## PUBLIC HEARING MEMORANDUM

**SUBJECT:** **Petition #273-24**, Request to rezone 2 parcels as follows: 329-331 River Street (Section 44 Block 15 Lot 11) and 335 River Street (Section 44 Block 15 Lot 12) from SINGLE RESIDENCE 3 to MULTI RESIDENCE 1.

**Petition #274-24**, Request to allow six attached single-family dwellings in three buildings and to allow reduced parking stall depth at 329-331 River Street and 335 River Street

Re: Special Permit – 329-331-335 River Street

Proposed conditions

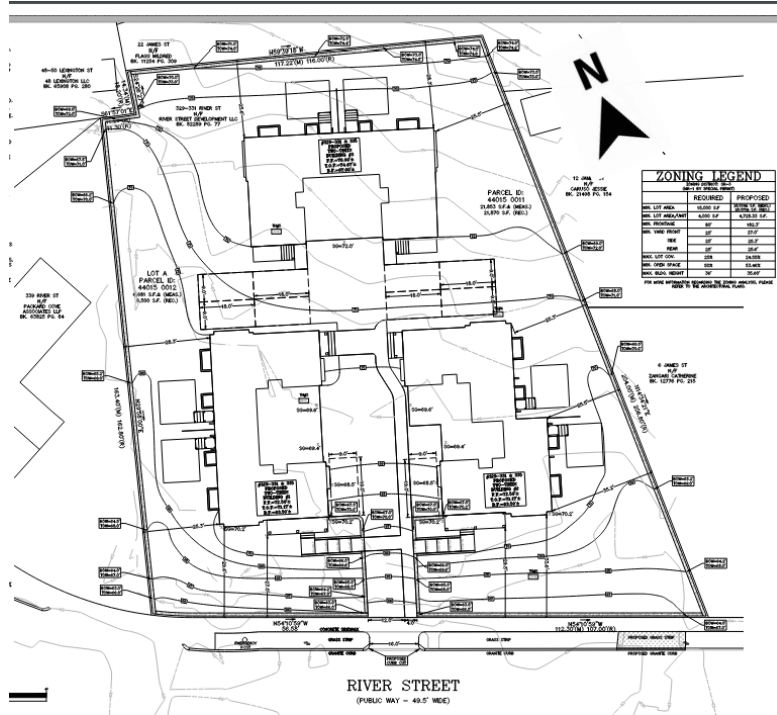
A retaining wall is proposed along three sides of the property, with only the rear property line and a 16-foot-wide opening along the frontage for the driveway lacking a perimeter retaining wall. Because no portion of the wall is shown at or above four feet, this wall system does not require relief. However, Planning staff note that the extensive use of retaining walls may have the potential to alter the natural flow and

infiltration of water on the site. Based on the contour and retaining wall elevations on the existing and proposed plan, the site will be regraded, and portions of the site raised several feet from the current elevation. The most significant grading work will be near the front portion of the site near the street, where the grade will be raised in some areas approximately four to five feet, thus resulting in dwellings at a higher elevation than the surrounding homes. Staff have requested the petitioner provide sections to better illustrate the proposed grade change.

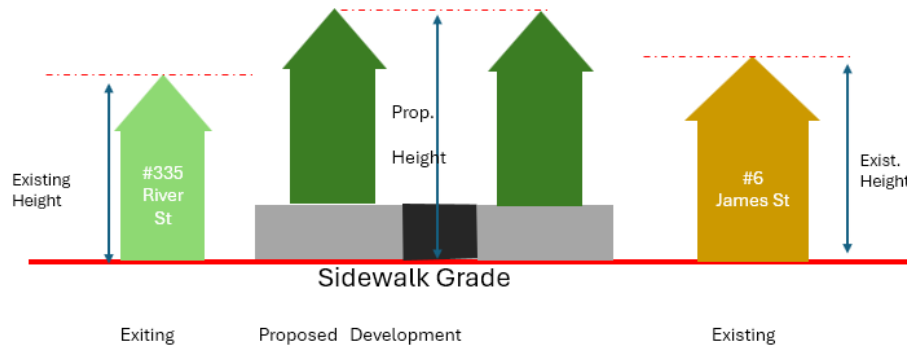
The heavy red line around the entire perimeter depicts the proposed retaining wall. In reading the various top & bottom proposed elevations of wall it is clear that the site is being raised from its natural existing state. The various wall heights are indicated inboard of the proposed wall.

For clarify of massing of the proposed development, a couple of site sections should be generated to scale that includes the abutting property dwellings in schematic format shown below.

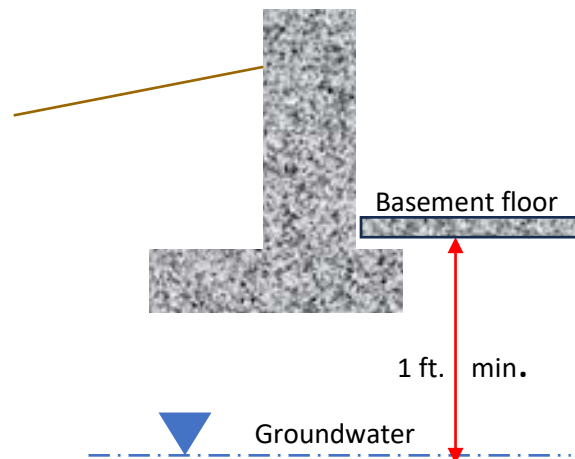
Groundwater depth varied throughout the site being the shallowest at test pit # 5 which is located within the proposed footprint of building # 3 towards the rear of the lot (See page 4).

The City Stormwater Ordinance requires a one (1-ft) separation between the underside of the basement slab and the seasonal high groundwater elevation. Additionally, a two (2-ft) separation is required between the bottom of the proposed infiltration system and the ground water.

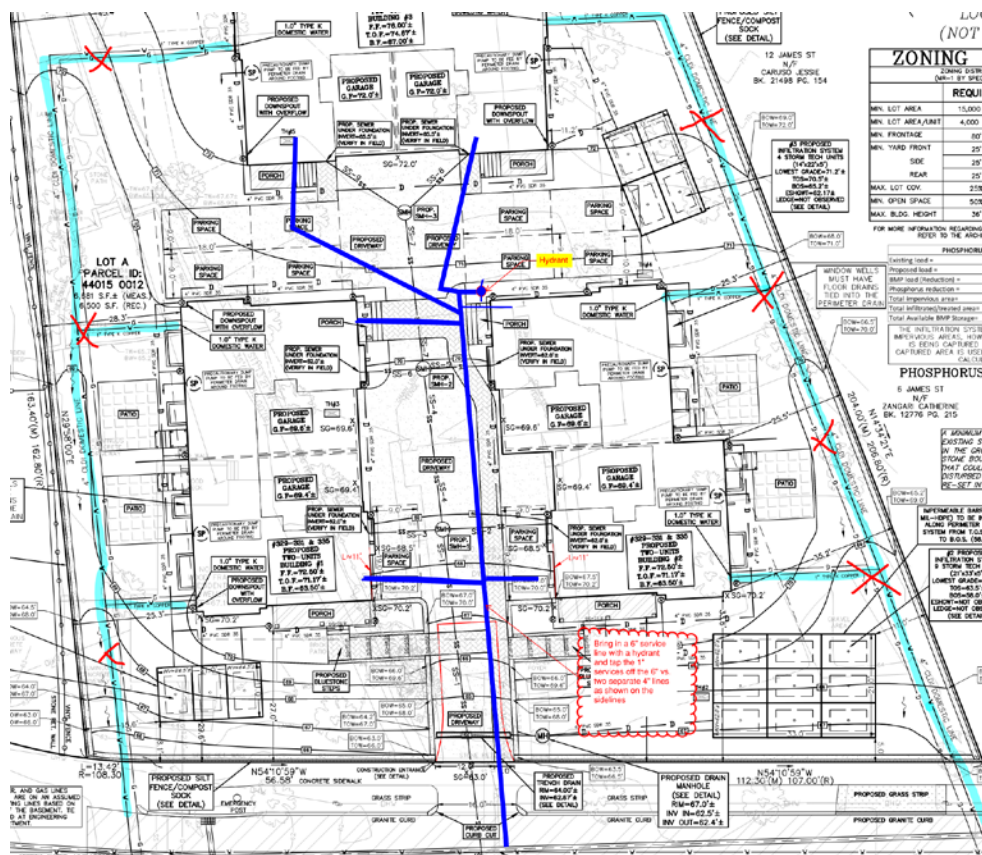
The proposed water services for the development is unacceptable according to the Utilities Division, the two four-inch lines should be consolidated into one 6-inch ductile iron pipe and have the individual service connections tapped from this 6-inch line, additionally the Fire Dept. may require fire suppression system for the units, the applicant shall confirm with Fire Prevention if this is needed (See following markup).
